PUBLIC BUILDING COMMISSION OF CHICAGO

ADDENDUM NO.02 TO CONTRACT NO. 1521  
FOR

BACK OF THE YARDS HIGH SCHOOL  
2111 W. 47TH STREET  
NEW CONSTRUCTION  
PROJECT # 05150

**NOTICE OF CHANGES IN CONTRACT DOCUMENTS**

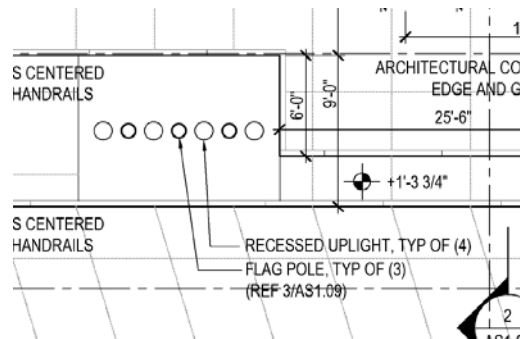
- Q27** Detail 3 on AS1.09 indicates granite paving at flagpole area

Plan views on AS1.02 at flagpole area do not detail this area as granite.

Please confirm extent of granite if required.

Please see Addendum #2, Change 25.

3/AS1.09 is correct in that the ground at the flagpole area is granite. The granite surface extends 12' in the North-South direction, aligning at the north with the adjacent step. The granite runs continuously in the East-West direction at the 1'-3 3/4" plaza elevation. Sheet AS1.02 has been issued in Addendum 2 with dimensional and textual annotations.
